ACM supports NHTSA's proposal to establish more modern headlight regulations but has some additional comments for consideration regarding the specifics of NHTSA's Notice of Proposed Rulemaking (NPRM). The comments that follow were developed as part of the American Center for Mobility IAB Standards Committee's testing efforts. The content does not represent the opinion of any one company on the committee.

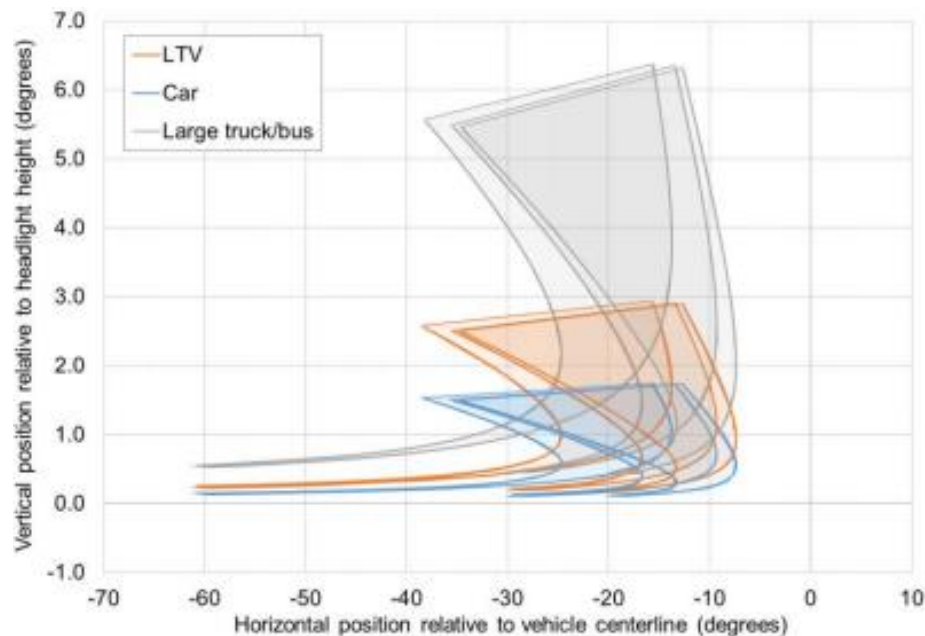
As previously stated, IIHS provided data showing overlap throughout the proposed scenarios, which can be seen in Figure 1:

While it shows that most of the total tested area for the proposed scenarios overlaps with at least one other scenario, it also provides ACM with possible angular limits for the positions of the stimulus vehicle relative to the ADB vehicle. Thus, ACM proposes performing modified test scenarios to those specified in SAE J3069 to determine static stimulus positions and orientations that provide data similar to that seen in figure above. This would entail performing straight line scenarios with various stimulus fixture locations. This can be visualized in the in Figure 2 below.

Figure 3: Angular Position of Passenger Vehicle Target Eye relative to VUT at Various Lateral Lane Offsets from 5m to 170m Longitudinally

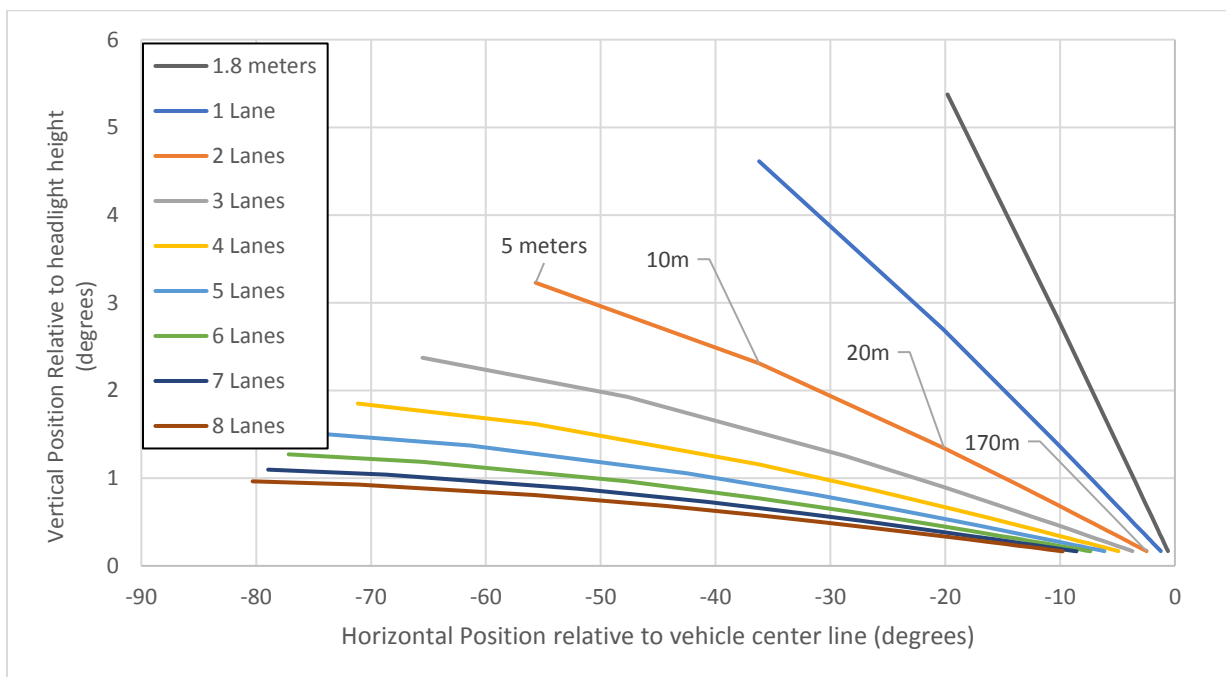
Based on the charts below, running straight line tests at various lateral offsets can test a much larger field of view than the curved tests currently proposed by NHTSA. Each line represents a straight path parallel to the VUT from 170 meters to 5 meters away, at the listed lateral offset, with each lane being 3.66 meters. The passenger vehicle target eye height was 0.5 meters above the VUT headlights, and the truck target eye height was 1.6 meters above the VUT headlights.

Figure 5: Comparing Total Viewable Area for Trucks and Passenger Cars in Straight Line Tests to Area from NHTSA Curved Test, as Identified by IIHS

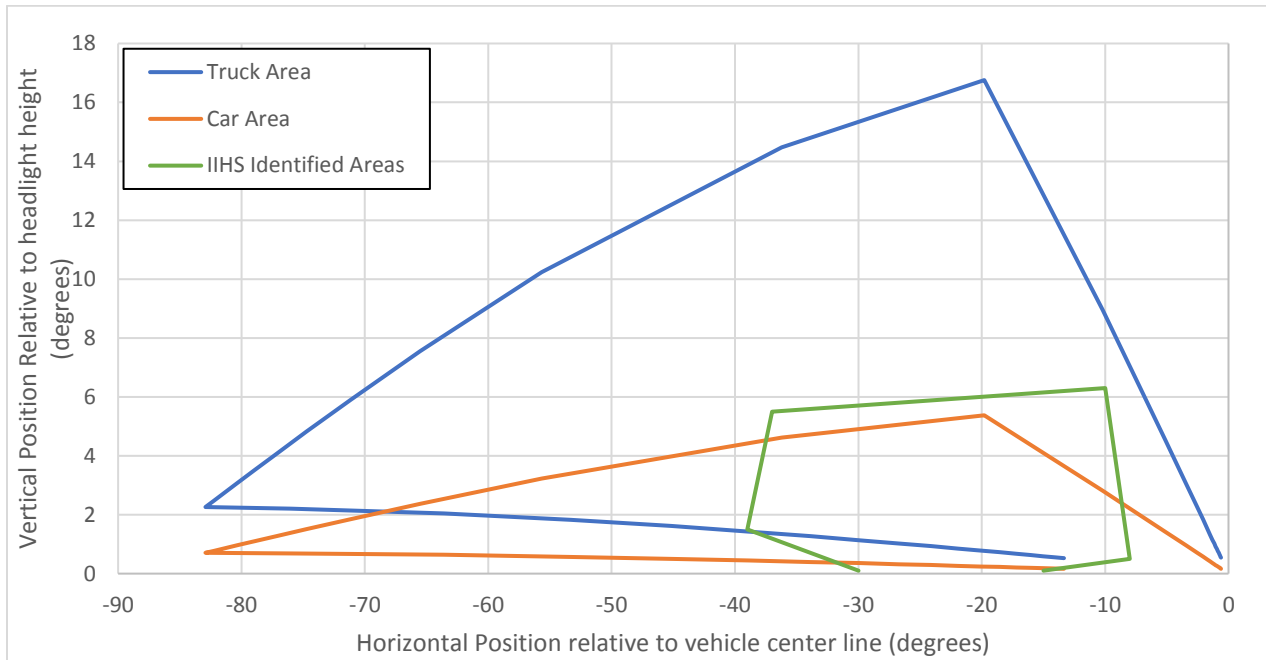
Plotting the edge cases from Figures 3 and 4 yields Figure 5. The area boxed in green is roughly the area designated by IIHS in their analysis showing the ADB's viewable area being tested. This shows that a series of straight-line tests with varying lateral offsets can cover an even larger viewable area than the curved tests, and so the curved tests could possibly be replaced entirely.
